Access Compliance Report

Public Rights-of-Way

(Curb Ramps)

Intersection ID: 15253	Main Street: ALBEMARLE_RD	Cross Street: E_W_T_HARRIS_BV	Location: SW
ADA ID: 9697396DE36F	Ramp Type: PerpDiag	Initial Pass/Fail: Fail	Overall Compliance: No
Severity Score: 13.75			
Codes/Mitigation Info/Possible Solution		Field Measurements/Component Compliance

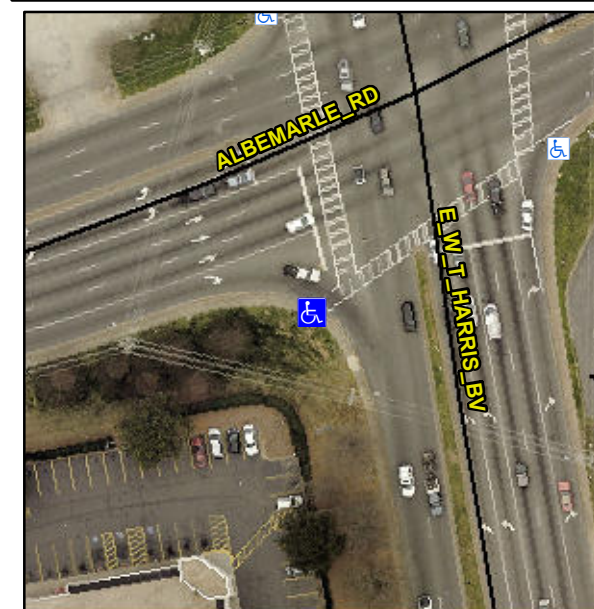
Not Found, R304.2.2

Compliance	Description	Data	Compliance	Description	Data
N/A	Ramp Length (in)	61.5	No	Ramp Slope (%)	10.1
Yes	Ramp Width (in)	70.0	Yes	Ramp XSlope (%)	3.6
N/A	Flare Type LT	N/A	N/A	Flare Type RT	N/A
N/A	Flare Slope LT (%)	N/A	N/A	Flare Slope RT (%)	N/A
N/A	Flare Traversable LT?	N/A	N/A	Flare Traversable RT?	N/A
N/A	Landing Length (in)	N/A	N/A	DWS Provided?	N/A
N/A	Landing Width (in)	N/A	N/A	DWS Contrast?	N/A
N/A	Landing Slope (%)	N/A	N/A	DWS Length (in)	N/A
N/A	Landing X Slope (%)	N/A	N/A	DWS Full Width?	N/A
N/A	Landing Curb? (Y/N)	N/A	N/A	DWS Offset (in)	N/A
N/A	Shared Landing?	N/A			
N/A	Gutter Ponding?	N/A	N/A	Gutter Slope (%)	N/A
N/A	Gutter Lip Ht (in)	N/A	N/A	Gutter X Slope (%)	N/A
N/A	Painted X Walk1?	Yes	N/A	Painted X Walk2?	Yes
	X Walk 1 Direction	To E		X Walk 2 Direction	To N
N/A	X Walk 1 Width (in)	84.0	N/A	X Walk 2 Width (in)	118.0
	X Walk 1 Slope (%)	1.7		X Walk 2 Slope (%)	4.2
	X Walk 1 X Slope (%)	5.3		X Walk 2 X Slope (%)	0.1

Remove & Replace Curb Ramp With Two New Directional Ramps or Equivalent.
